SERVICE MEMORANDUM

MGF/53

29 Sept. 1960

TIMING CHAIN TENSIONER

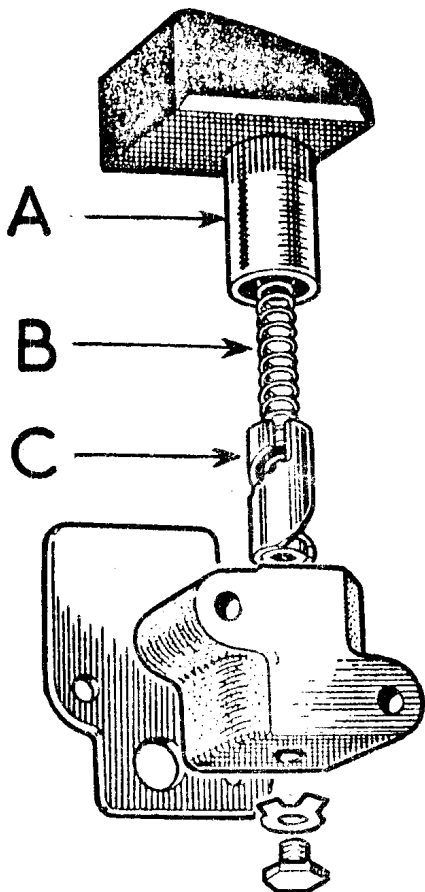
The slipper head assembly of the timing chain tensioner fitted to the above is now offered as a service part under Part No. 17H31.

This assembly, which consists of the slipper head ('A' in sketch), spring 'B' and plunger 'C', may be used as a replacement in the original body, provided that the latter is not damaged or unduly worn.

If the mouth of the bore of the body has worn oval by more than .003" (.76 mm.), then the body should be scrapped and a complete new tensioner fitted.
